**NOTICE OF ADDENDUM
ADDENDUM NO. 2
City of Madison, Engineering Department**

**CONTRACT NO. 7769
SYCAMORE AVE. PUBLIC WORKS MAINTENANCE FACILITY-OFFICE REMODEL PROJECT**

1 FIRST FLOOR OFFICE REMODEL
SCALE: 1/8" = 1'-0"

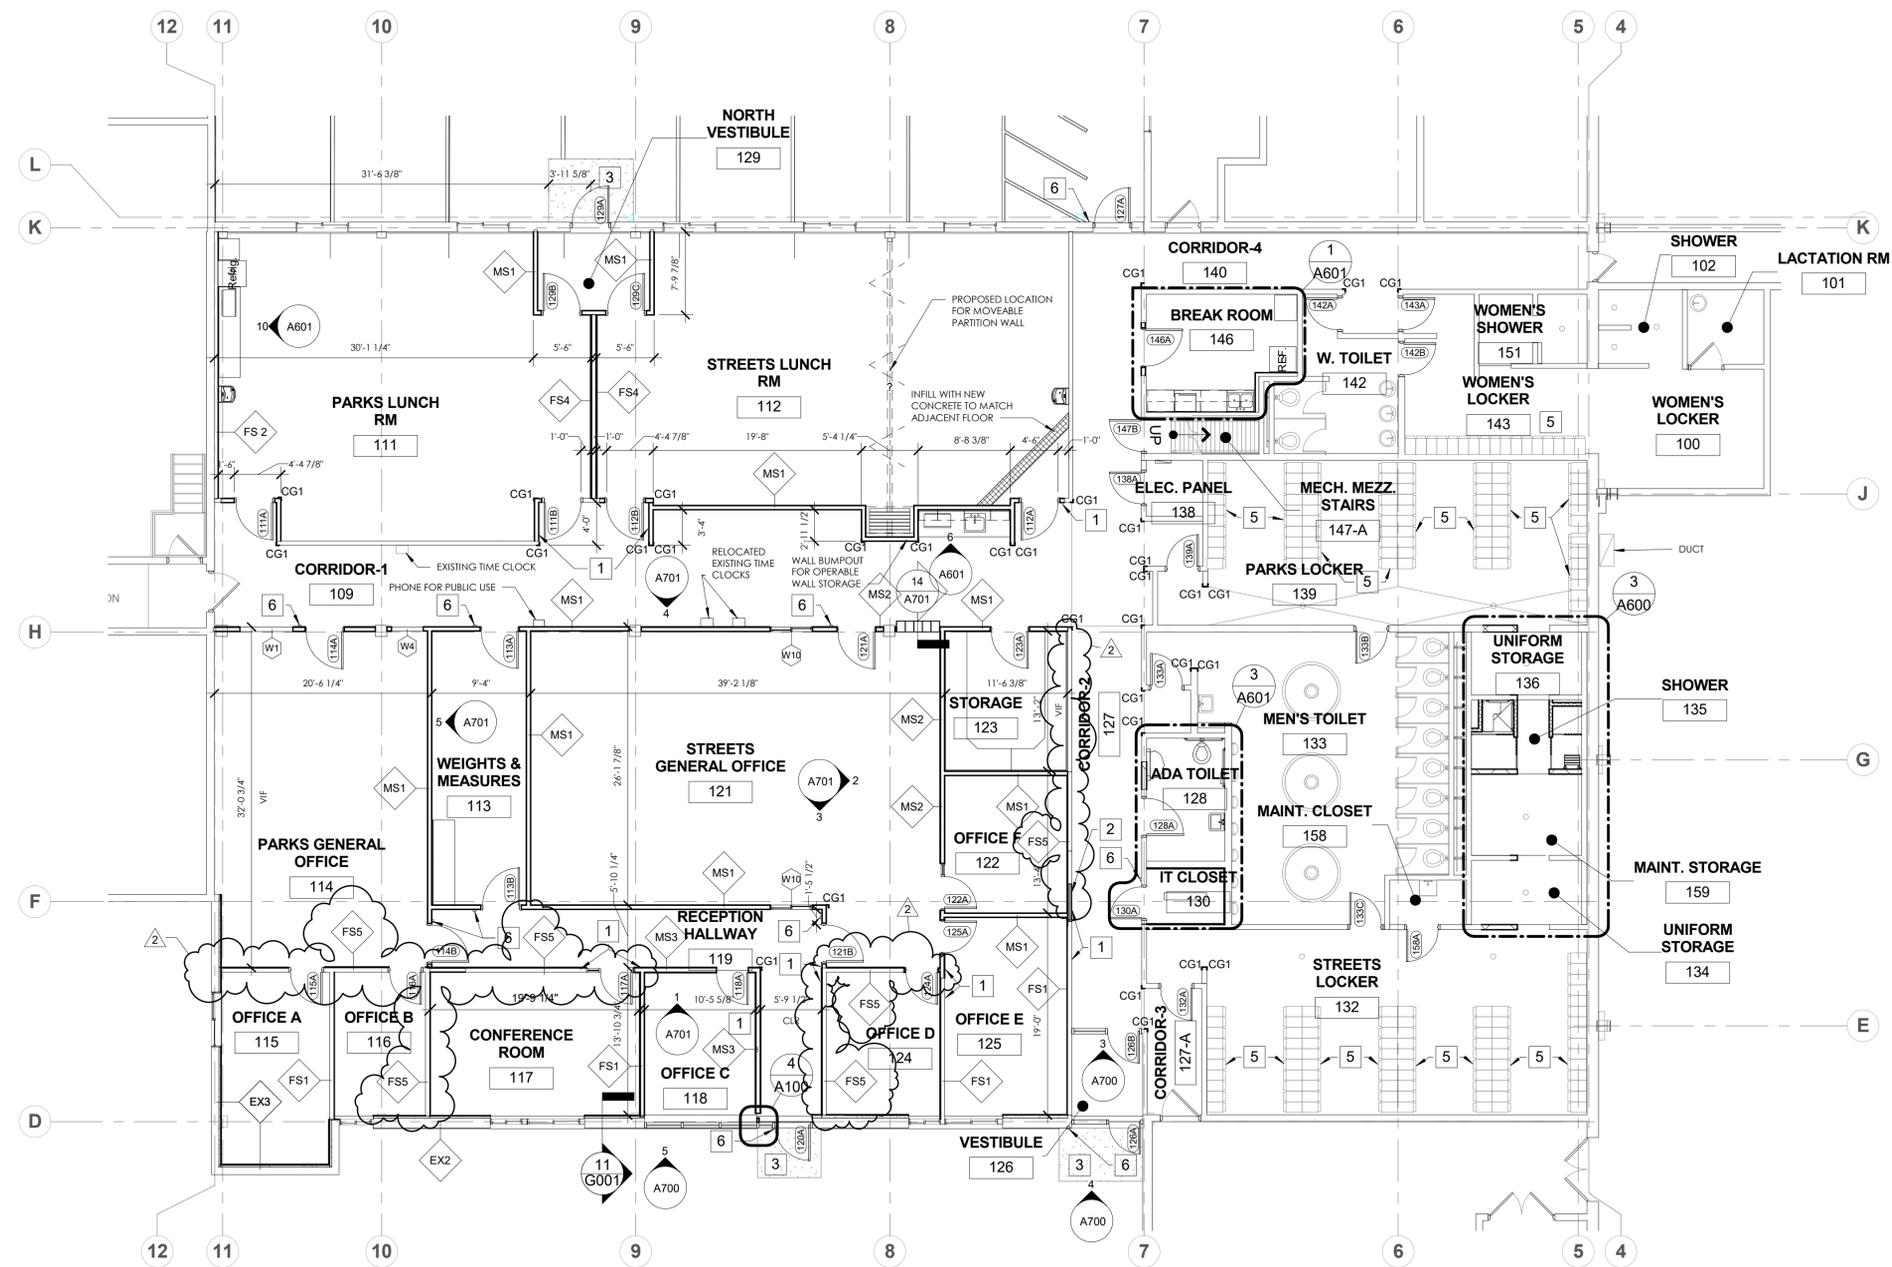
- i. **Drawing G001: (Remove and replace with attached sheet):** Partition type FS5 added.
- ii. **Drawing A100: (Remove and replace with attached sheet):** Partition callouts revised in rooms 115, 116, 117, 122, 123, 124.
